Re: Thunder Bay Hydro Electricity Distribution Inc. 2017 Electricity Rate Application
AMPCO Submission
Board File No. EB-2016-0105

**Thunder Bay Hydro Electricity Distribution Inc.
2017 Electricity Distribution Rate Application
EB-2016-0105**

Figure 35 - TBHEDI Vegetation Management Budget Escalation

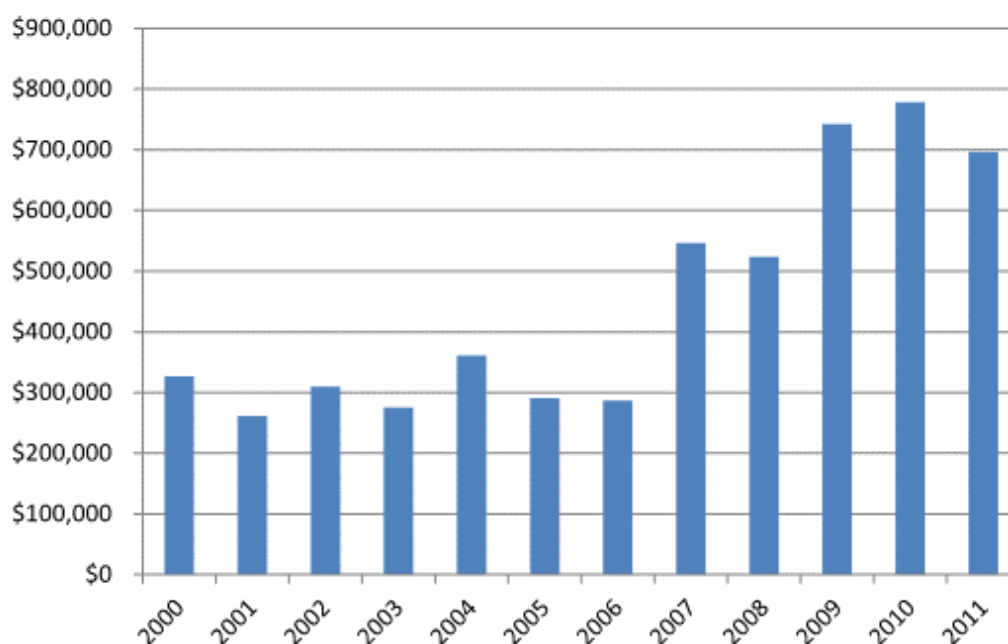
In 2012, the Forestry Management budget was set at \$720,000.⁶⁶ Forecast spending in 2013 was consistent with 2012 to keep pace with the Forestry Plan. The Program anticipated a focus on areas with substantial overgrowth with funding levels to remain constant for 4 or 5 years beyond 2013. Even though Thunder Bay Hydro has ramped up its Tree Trimming budget it has not yet achieved a 7-year trimming cycle as planned. More funding is being asked for now, and achievement of a 7-year trimming cycle is still 10 years away or more. It is unclear what the additional budget is needed for given that the Thunder Bay Hydro has been working on reaching a 7-year cycle for the past few years.

In 4-VECC-38, Thunder Bay Hydro provided total Vegetation Clearing costs of \$4,761,454 to address 210 km⁶⁸ or \$748,228 annually (w/10% contingency) for a 7-year cycle. This budget and timeline information is confusing and does not align with the data underlying Thunder Bay Hydro's 2012 Forestry Management Plan. It is unclear why the total km to be addressed in the 7-year cycle has changed in the latest Tree Trimming estimate to 201 km in EB-2016-0105 from 695.2 km in EB-2012-0167. Also, the budget estimate provided is for a 7-year cycle and given Thunder Bay Hydro is not yet on a 7-year cycle, it is unclear what the Tree Trimming budget for 2017 is based on.
